Comment i-423

PROPOSED ACCEPT IN PRINCIPLE

Multiple editorial changes are required in both the PCS Receive and PCS Transmit functions subclauses to address the lack of clarity pointed out by the commenter.

Figure 147-6—Self-synchronizing scrambler

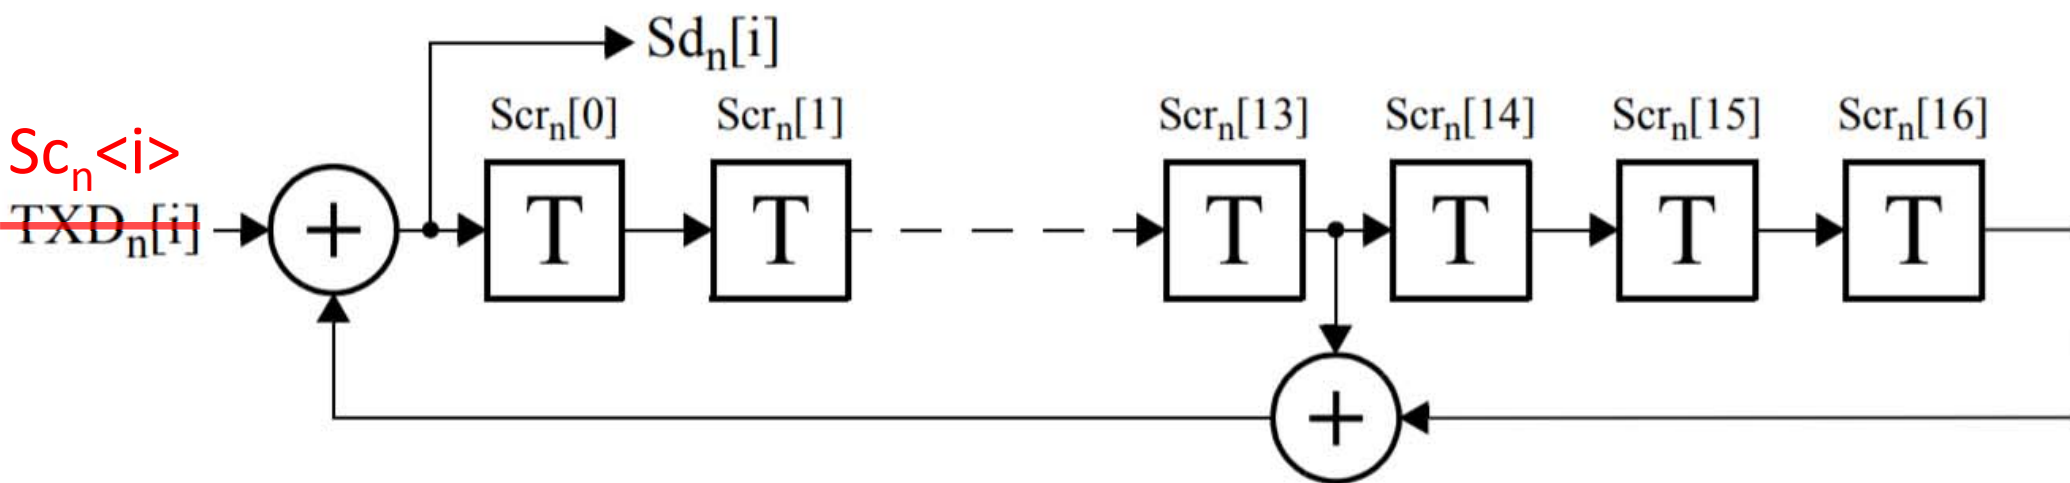
An implementation of a self-synchronizing scrambler by a linear-feedback shift register is shown in Figure 147–6. The bits stored in the shift register delay line at time n are denoted by $Sc_n\langle 16:0 \rangle$. The '+' symbol denotes the exclusive OR logical operation. ~~At every MII clock cycle, for every bit of TXD[3:0], the scrambler is advanced by one bit, and the output bit Sdn[i] represented by the exclusive OR of Scn[13], Scn[16] and TXD[i] is shifted in as a new Scn[0], with i ranging from 0 to 3 (i.e., LSB first) When Sc_n<3:0> is presented at the input of the scrambler, Sd_n<3:0> is produced by shifting-in each bit of Sc_n<3:0> as Sc_n<i>, with i ranging from 0 to 3 (i.e., LSB first). The scrambler is reset upon execution of the PCS Reset function. If the PCS Reset is executed, all bits of the 17-bit vector representing the self-synchronizing scrambler state are arbitrarily set. The initialization of the scrambler state is left to the implementer. In no case shall the scrambler state be initialized to all zeroes. At every STD, if no data is presented at the scrambler input via Sc_n<3:0>, the scrambler may be fed with arbitrary inputs.~~

Additionally, change all square brackets '[']' with angular brackets '<>'

Figure 147-9—Self-synchronizing descrambler

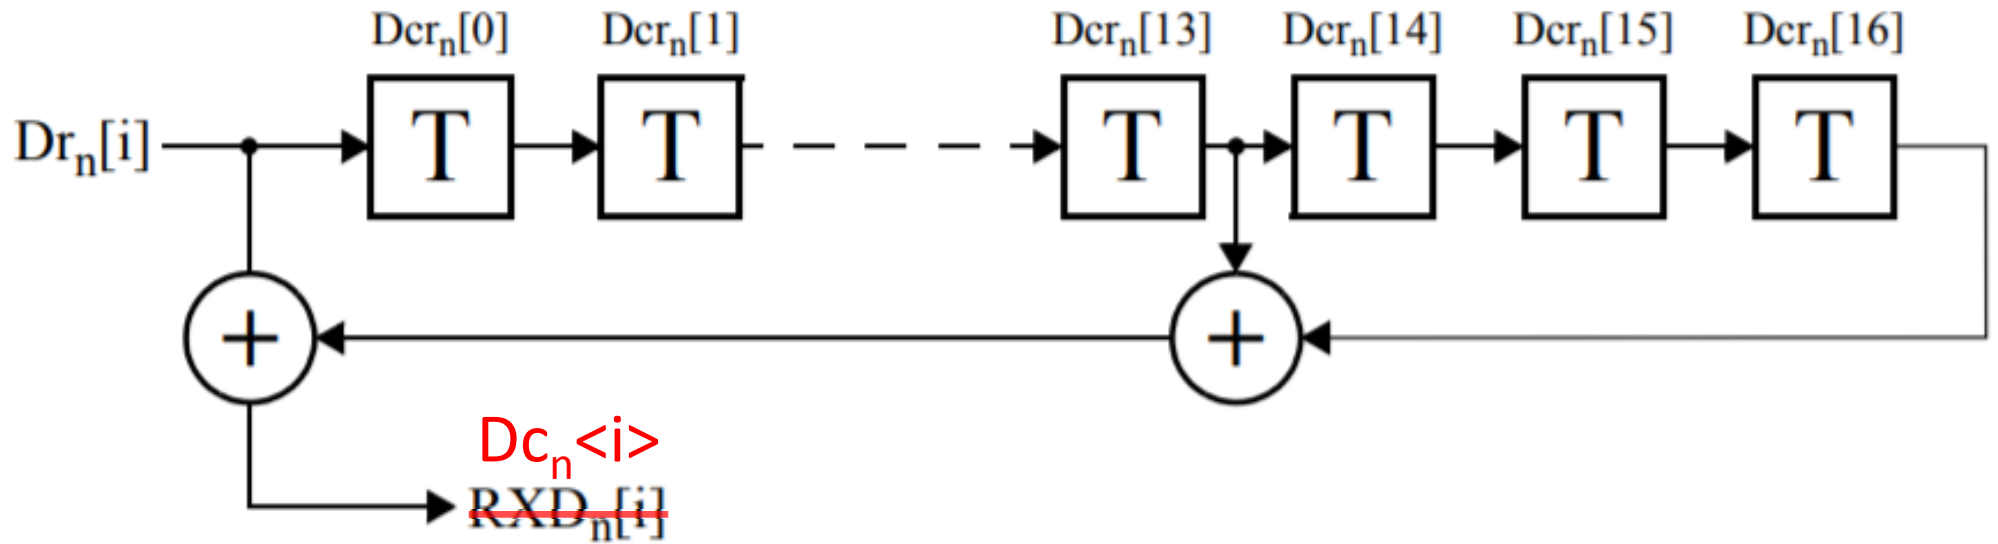
The PCS Receive function shall descrambles the 5B/4B decoded data stream and returns the ~~proper nibble for generation value~~ of RXD[3:0] to the MII. The descrambler shall employ the polynomial defined in 147.3.2.6. The implementation of the self-synchronizing descrambler by linear-feedback shift register is shown in Figure 147–9. The bits stored in the shift register delay line at time n are denoted by $Dcr_n[16:0]$. ~~The '+' symbol denotes the exclusive OR logical operation. At every MII clock cycle, each bit of $Dr_n[3:0]$ is shifted in as new $Dcr_n[0]$, and the descrambler is advanced by one bit. The output bit $RXD[i]$ represented by the exclusive OR of $Dcr_n[13]$, $Dcr_n[16]$, and $Dr_n[i]$ is generated~~ When $Dr_n<3:0>$ is presented at the input of the descrambler, $Dc_n<3:0>$ is produced by shifting-in each bit of $Dr_n<3:0>$ as $Dr_n<i>$, with i ranging from 0 to 3 (i.e., LSB first). The descrambler is reset upon execution of the PCS Reset function. If PCS Reset is executed, all the bits of the 17-bit vector representing the self-synchronizing descrambler state are arbitrarily set. The initialization of the descrambler state is left to the implementer. ~~At every RSCD, if no data is presented at the descrambler input via $Dr_n<3:0>$, the descrambler may be fed with arbitrary inputs.~~

Additionally, change all square brackets '[']' with angular brackets '<>'
